# Architectural Review Board

## Staff Report (ID # 9262)

| <b>Summary Title:</b> | 3945 El Camino: Comfort Inn Hotel Renovation (2nd Formal)                                                                                                                                                                                                                                                                                                                                                                                                                                                                                                                                                  |                               |
| <b>Title:</b>         | PUBLIC HEARING / QUASI-JUDICIAL. 3945 El Camino Real [16PLN-00374]: Request for Approval of a Major Architectural Review to Allow an Exterior Remodel of an Existing Two-Story Hotel Building at 3945 El Camino Real. Environmental Assessment: The Project is Exempt from CEQA per Guideline Section 15301 (Existing Facilities). Zoning District: Medium Density Multiple-Family Residence District (RM-30) and Service Commercial (CS). For more information, contact the project

**Figure 1**

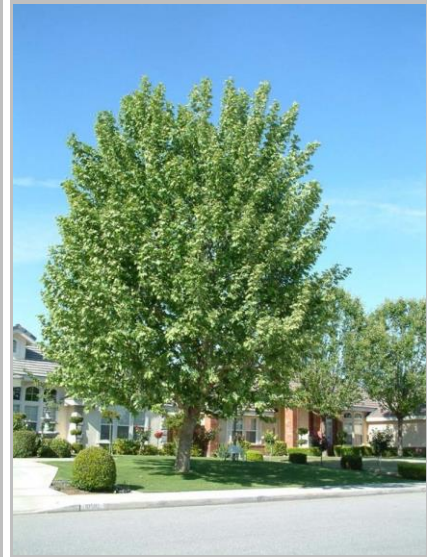
Members of the ARB suggested the applicant utilize different tree species than the proposed London Plane and Oak as primary trees in the interior landscape areas. In response, the

applicant has proposed new native California tree species; one (1) Pacific Madrone to serve as the featured outdoor patio tree; two (2) Catalina Ironwood trees for the large stair tower planters; and three (3) California Sycamore trees for each of the parking island planters. The California Sycamore is deciduous, while the Pacific Madrone and Catalina Ironwood are evergreen. All of the proposed trees will be 24 inch box size when planted. Photo examples of each tree species provided in Figure 1 below.

5. The landscape plan was revised to show three different tree types:
  - Pacific madrone (patio)
  - Catalina Ironwood (by the stair towers)
  - California Sycamore (parking)
